Re: Safety Defect Report

**SUBJECT: RECALL CAMPAIGN #40715
Draw Tite Hitch Receiver**

Cognate / Fleetwood Hitch Evaluation

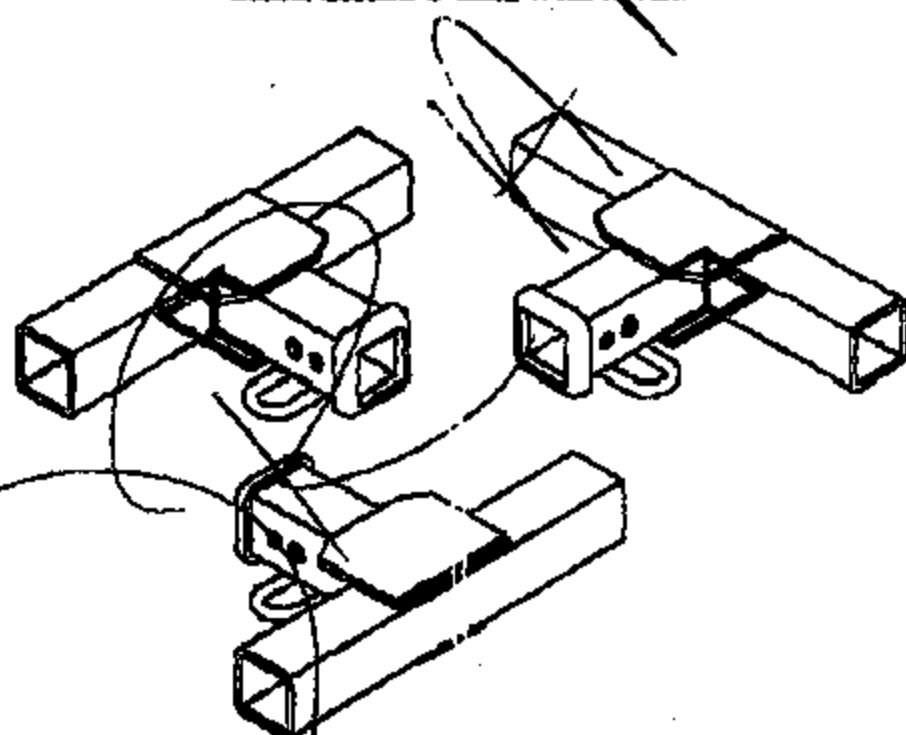
Center Section Critical Weld Review

-  Top Plate Welds
-  Bottom Plate Welds
-  Receiver Tube Welds

- All welds shown above in center section must be present.
- If welds are missing, remove hitch and replace.
- Some receivers may have additional welds which are not cause for rejection.

Cumant / Fleetwood Hitch Evaluation

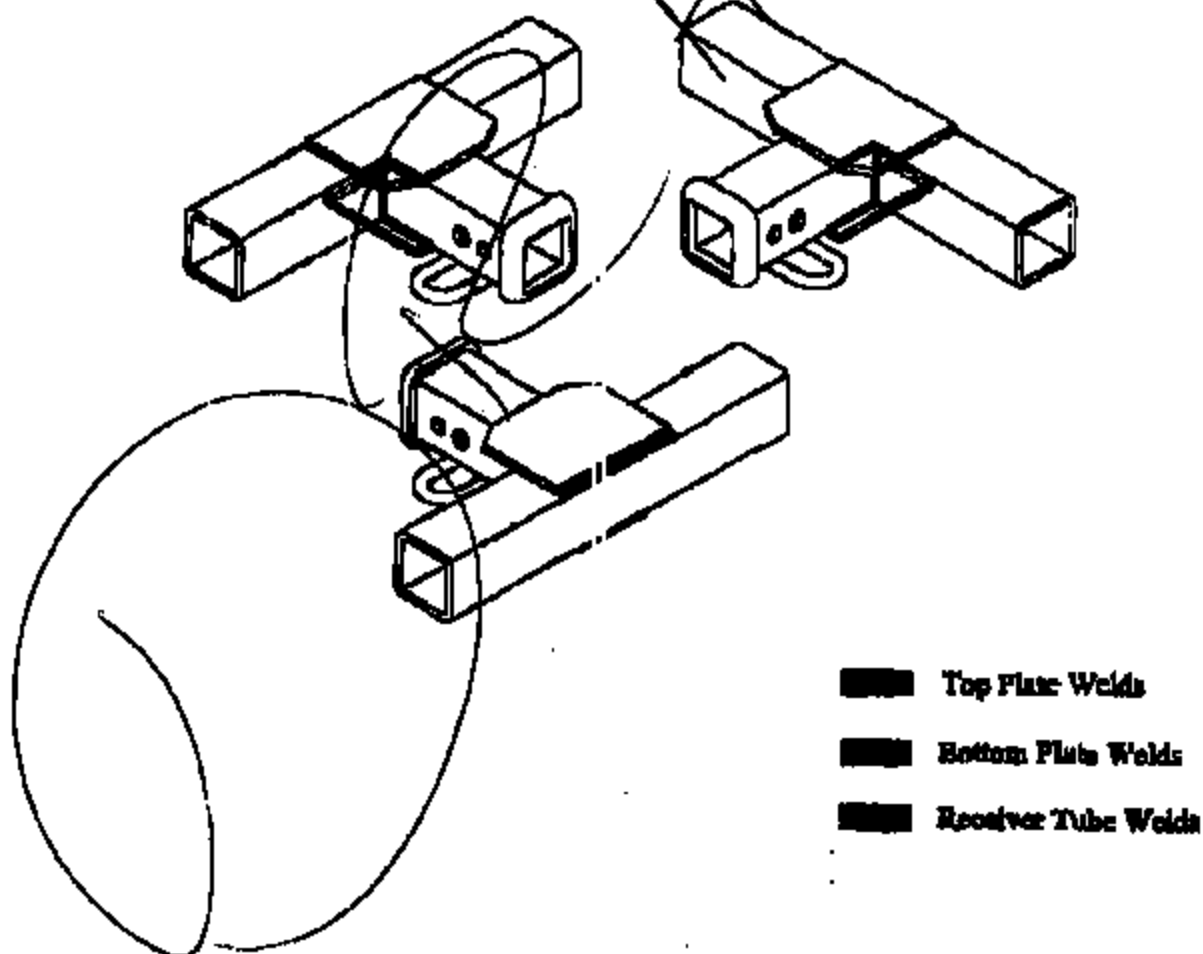
Center Section Critical Weld Review

- All welds shown above in center section must be present.
- If welds are missing, remove hitch and replace.
- Some receivers may have additional welds which are not cause for rejection.
